ADDITIONAL INFORMATION FOR UPGRADING IM-1

UPGRADE OF APF IMAGINATION MACHINE FROM 8K RAM TO 16K

Figure D-4
MPA-10 Main Board Parts Layout

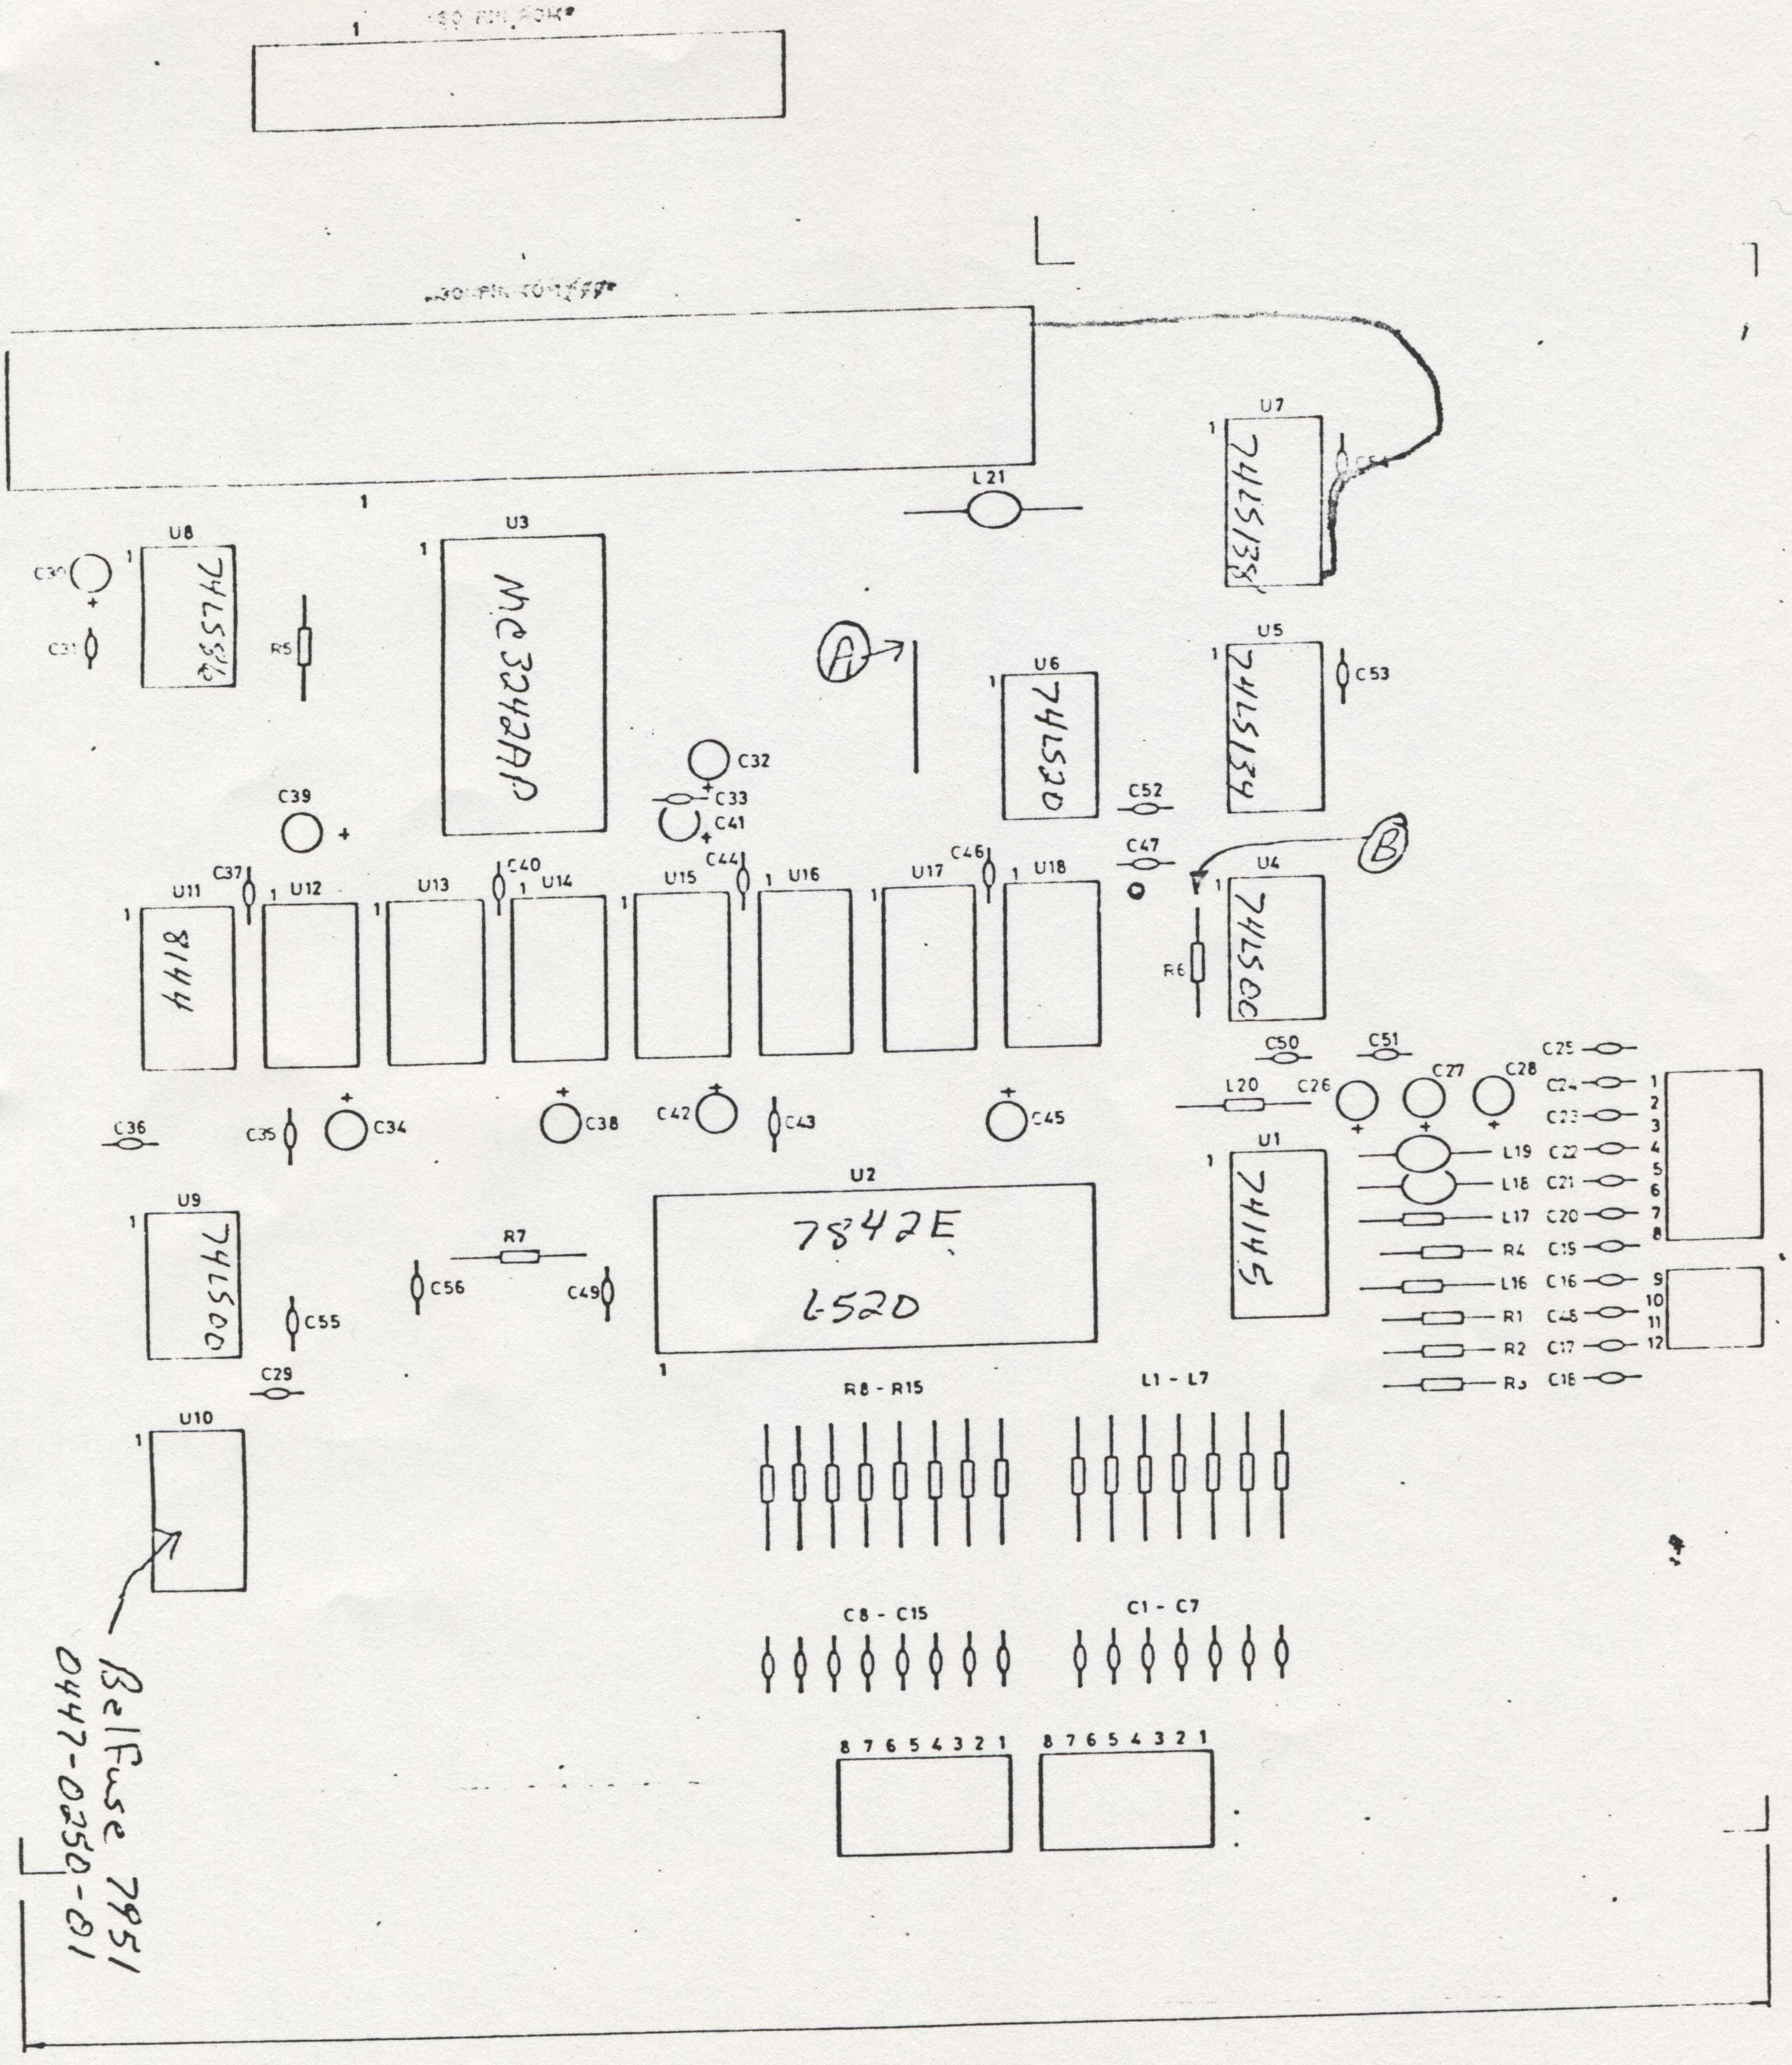
1. If this change is to be used with the building BLOCK one additional change has to be made in the circuit. Refer to D-4, you will find a circuit run which connects to U7 pin 9 and goes under C54 and then disappears under 30 pin to 1000 connector, this run will have to be cut. Any place is ok but I recommend around C54. On D-5 this signal is $\overline{\overline{\text{CD}}}$ going out to 50 pin expansion plug.

After opening your IM-1 do the following.
Refer to figures D3 and D4 enclosed.
1. On D4 find jumper in the middle of the board and remove end labeled A .

2. On D4 find R6 and remove from the board end labeled B . Be careful not to break resistor.
3. Next step is to put R6A,D1 and D2 togeather. This can be done by twisting 3 leads togeather and soldering. Be sure and tie the anode end of diodes togeather(Non-banded end). Cut of excess end of this junction leaving 1/3 inch of lead.

4. Now insert one of the leads from Diodes into hole that R6 was removed from in step 2. Solder and cut of excess lead.
5. NExt attach R6A(new resistor) to 5 volts. This can be done at U4 pin 14. Attach free end of R6A.

6. Next attach about 3 inches of wire to last diode and solder. Attach other end of wire to U5 pin 11. Careful not to overheat U5 or diode.
7. Next you attach R6 to the junction of R6A,D1 and D2 made in step 3 . Careful not to overheat or break componets.

8. Next step is to add wire to jumper removed in step 1 and solder. Then solder other end of wire to U7 pin 1.
9. Last step is remove U11 through U18 and replace with new chips. Save old chips for possible later use.
